SUBJECT: **Modification Request of Section 404 Regional General Permit No. 31 and Section 401 General Water Quality Certification No. 3886** for the proposed Interstate 85 (I-85) Widening and Interchange Improvements from north of NC 73 (Davidson Highway / Exit 55) to north of SR 2180 (Lane Street/Exit 63), Cabarrus & Rowan Counties, Divisions 9 and 10. Federal Aid Project No. FANHIMF-085-2(61)55, TIP Project No. I-3802A.

In addition to this cover letter, please find the revised permit drawings (Permit Drawing Sheet Nos. 61 – 65 of 128) and revised impact summary sheets (Permit Drawing Sheet Nos. 126 – 128 of 128).

**PERMIT DRAWING SHEET 64 OF 128**

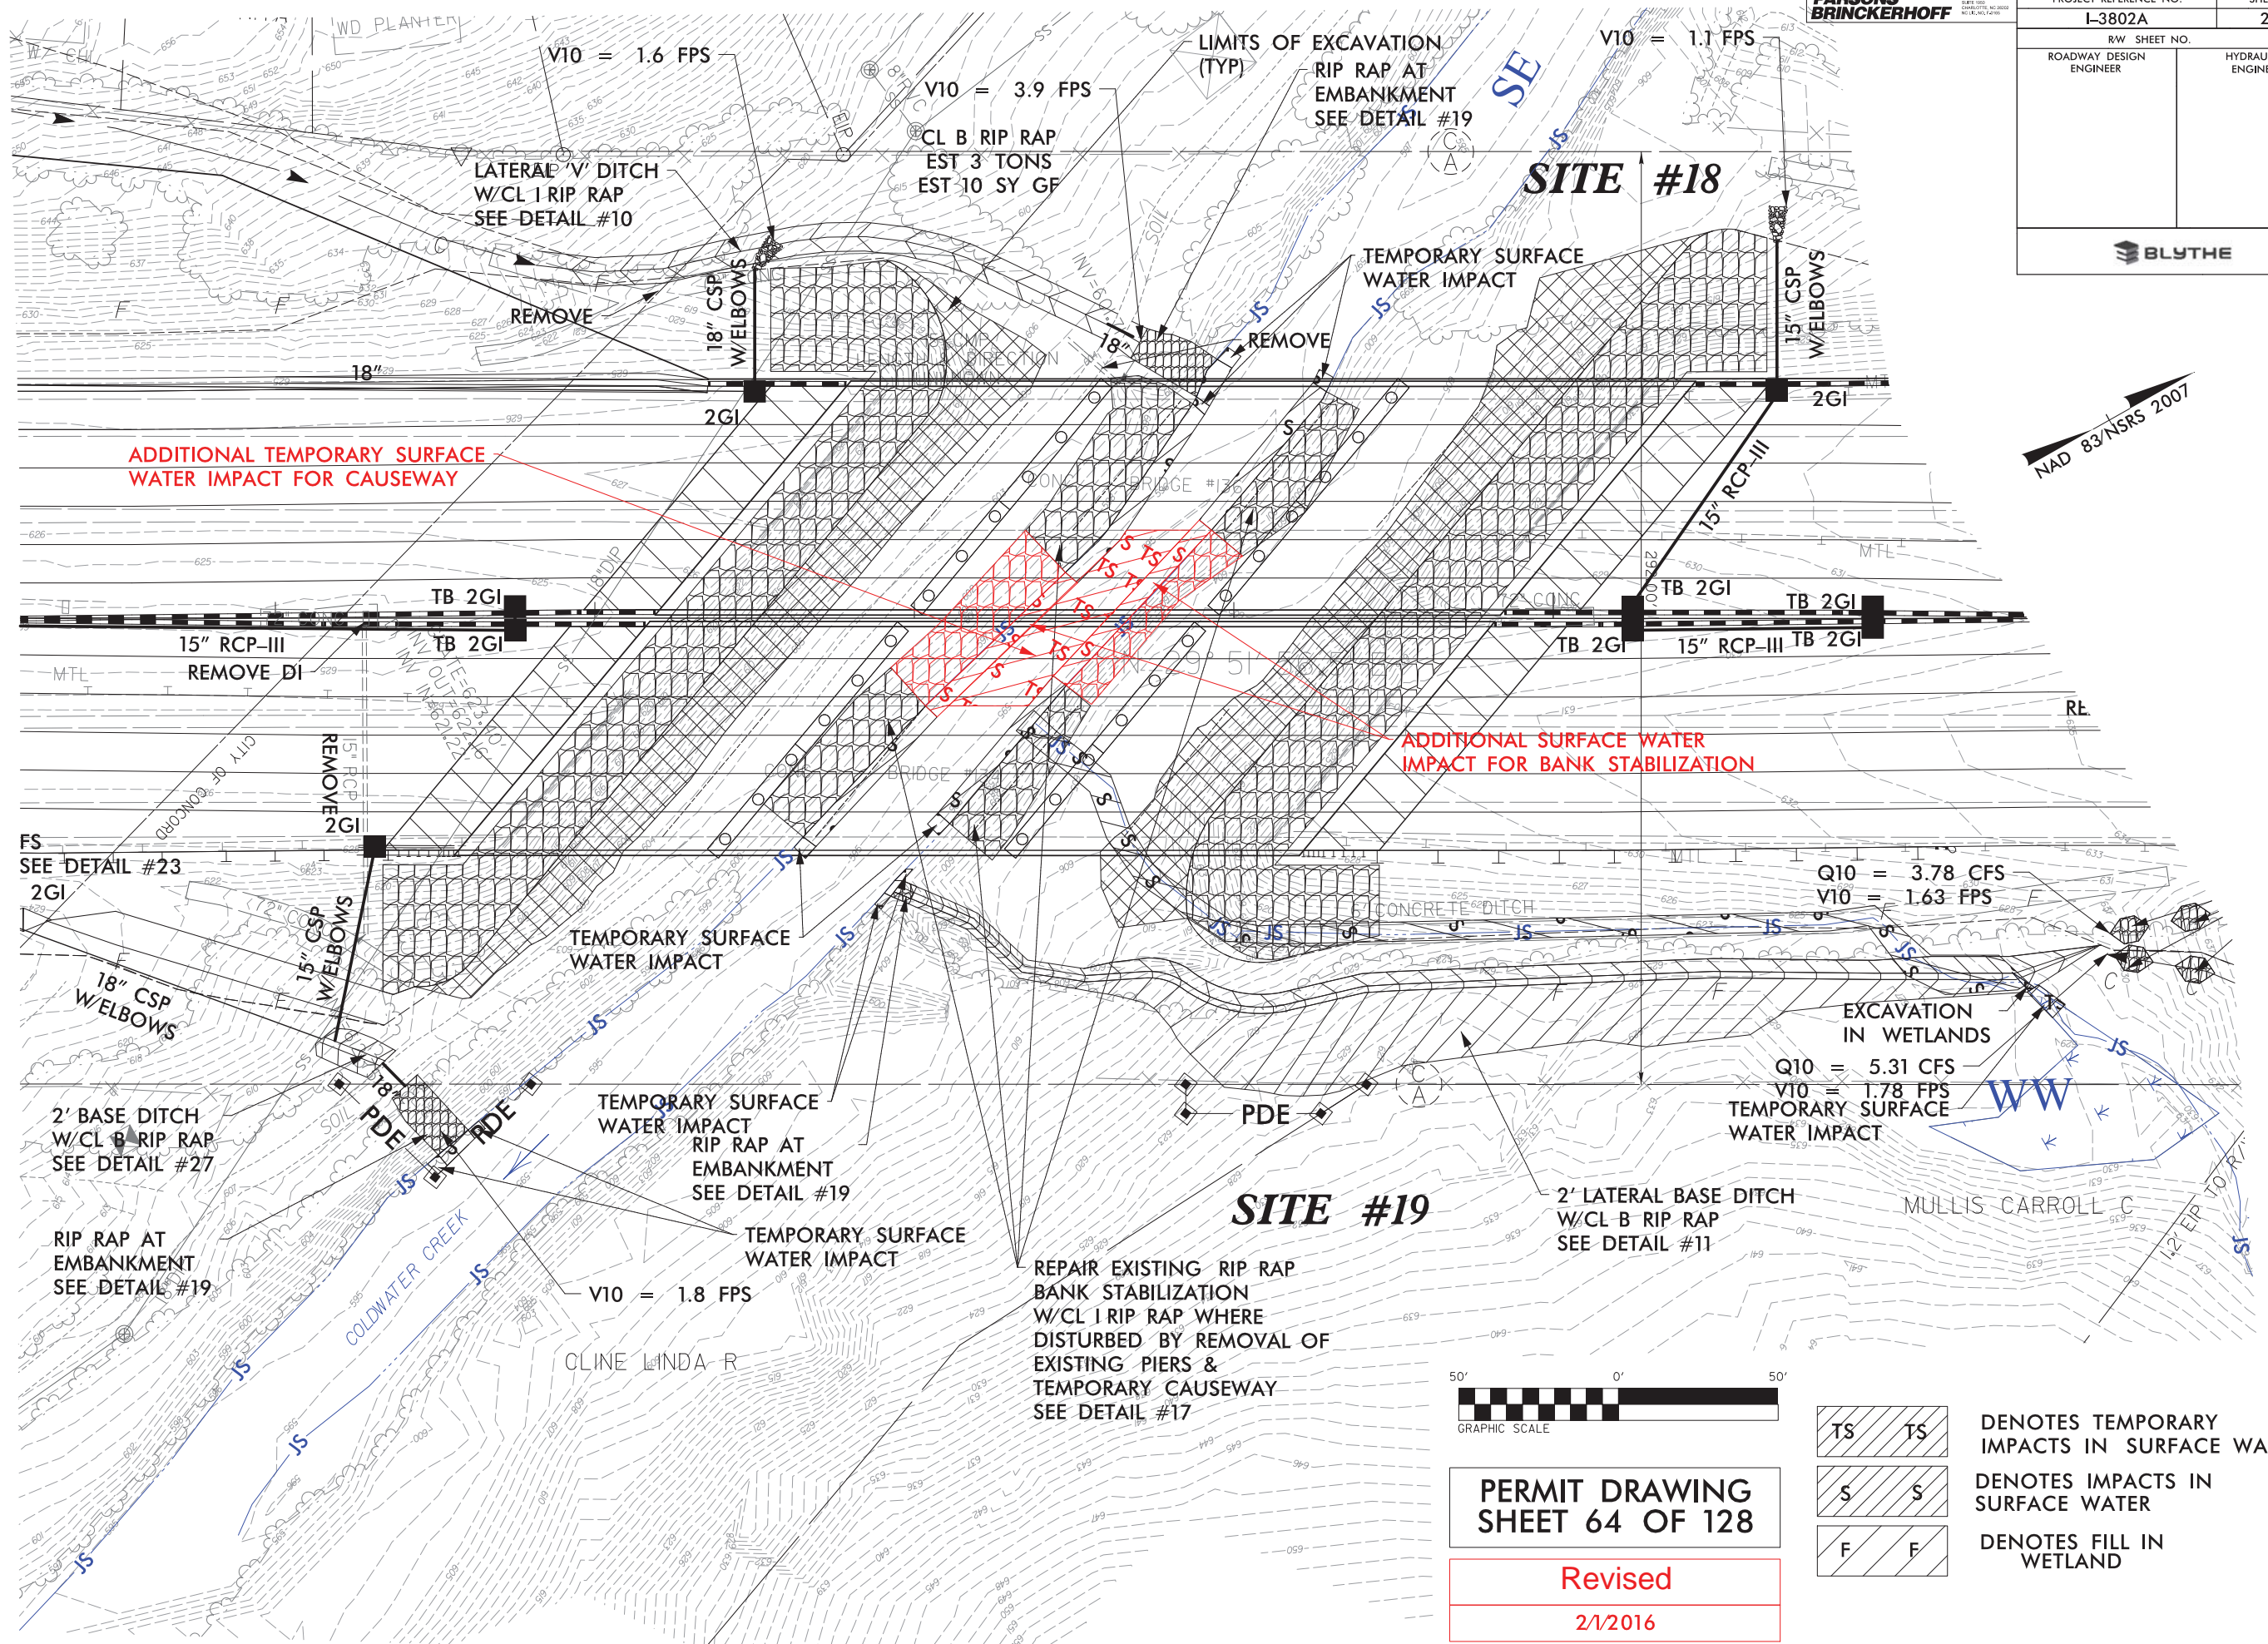
Since the issuance of the above-referenced permit approvals, design changes have occurred which necessitate the need for a temporary stream crossing across Cold Water Creek (Stream SE) and additional bank stabilization. This design change will modify jurisdictional impacts to Waters of the US at Permit Site No. 18.

The temporary causeway at Site 18 is required to enable construction of the proposed I-85 bridges over Cold Water Creek. The temporary stream crossing will utilize a stone causeway with three 72-inch pipe culverts. The causeway will be constructed from Class II riprap and will be topped with a Class B riprap work pad. Geotextile fabric will be installed between the Class II riprap and the stream bed and stream banks. The culverts will allow for 50% or greater flow of the creek through the causeway.

Bank stabilization consisting of Class II riprap will be installed where the stream banks have been impacted by installation of the causeway.
